Concerns regarding the clock model used in 60802 time synchronization simulations

December 21, 2020 IEC/IEEE 60802 Joint Project Call

Jordon Woods, Analog Devices

Figure 3. Typical PWA Thermal Cycling Profile

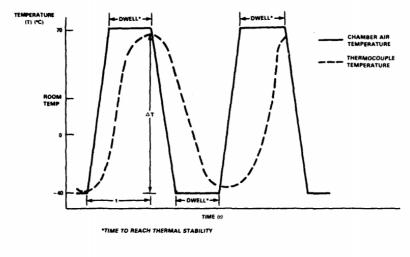
- Develop a frequency stability model for the local clock that depends on temperature
 - Calculate f based upon the enclosed formula or a suitable alternative.
 - Randomly assign f0 based upon frequency tolerance rather than frequency stability.
 - Choose representative values for T0 (25 C), and TC (0.050 ppm/°C2)
 - Select a representative thermal profile/cycle
 - -40 to +85 C; 25 C/min w/ 5-minute soak yields a period of 20 minutes
